Our Ref: 2111
Your Ref: DA/4957

**RESPONSE TO INFORMATION REQUEST
DEVELOPMENT APPLICATION FOR RECONFIGURING A LOT (1 LOT INTO 2 LOTS & ACCESS EASEMENT)
232 SHIPTONS FLAT ROAD, ROSSVILLE – LOT 2 ON SP301676**

Figure 2: Extract of plan of proposed reconfiguration showing the nature the proposed easements and the access arrangements to each of the proposed lots

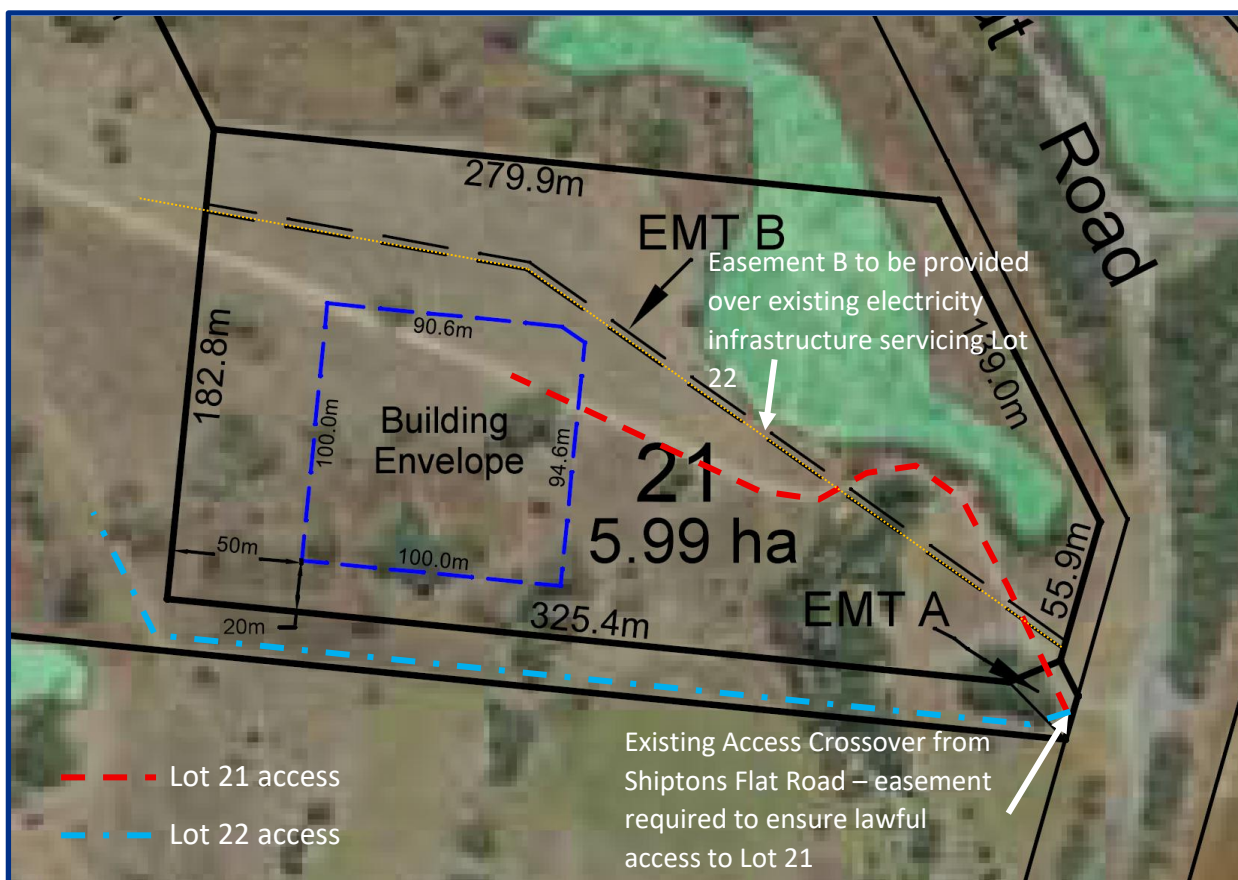
All proposed allotments are required to provide lawful and practical site access without reliance on adjoining land. The submitted subdivision plan identifies an access easement over Lot 21 benefitting Lot 22. However, as currently presented, access to Lot 22 is discontinuous. Easements A and B are not connected, and the alignment of Easement B is obstructed by an existing watercourse, making it unsuitable for vehicle or pedestrian access.

1. *The applicant is requested to provide amended subdivision plans that demonstrate a continuous and trafficable access arrangement from the road reserve to proposed Lot 22.*

2. *The applicant is requested to provide justification for why access to Lot 22 cannot be wholly contained within the proposed lot boundaries.*

3. The applicant is further requested to detail how any potential amenity, safety, and functional impacts associated with the proposed access easement over Lot 21 will be mitigated.

In order to provide lawful access to proposed Lot 21 it is proposed to provide an Access Easement (Easement A) over the part of the access handle of proposed Lot 22, from the frontage at Shiptons Flat Road to the frontage of proposed Lot 21. Access to proposed Lot 22 will be wholly contained within the access handle associated with the allotment.

Figure 1 above also illustrates the existing electricity infrastructure that is located at the frontage of the subject land. The electricity infrastructure that services the existing buildings and structures located on proposed Lot 22 traverses from the power pole shown in Figure 1 through proposed Lot 21, where Easement B is proposed. Easement B is required over the electricity infrastructure to protect the ongoing provision of the service.

Figure 2 below illustrates nature of proposed Easements A, being an Access Easement over Lot 22 to provide lawful access to Lot 21, the proposed access arrangements to Lots 21 and 22 and the nature of proposed Easement B over existing electricity infrastructure that traverses Lot 21 and services Lot 22.

Figure 3: Annotated image of plan of proposed reconfiguration

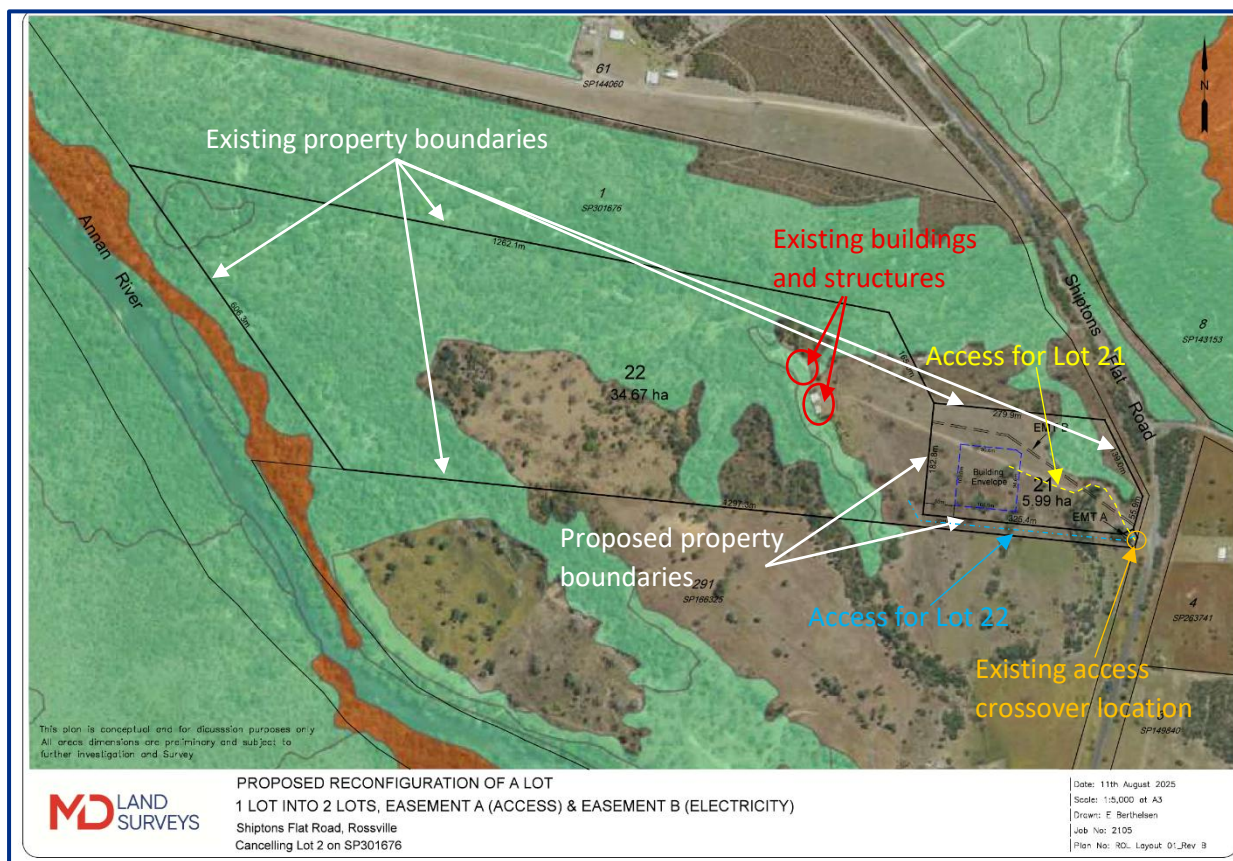
4. Please provide an updated site plan to show:
 - a. All existing and proposed boundary lines;
 - b. All existing buildings and structures;
 - c. All existing and proposed driveways/vehicular crossings;
 - d. Identify and notate all existing structures on site.

Figure 3 below, provides an annotated image of plan of proposed reconfiguration that was submitted with the Development Application, identifying that each of the abovementioned items are included on the plan.

Given that the plan of proposed reconfiguration as submitted with the Development Application identifies each of these items, the provision of an updated plan is not considered necessary.
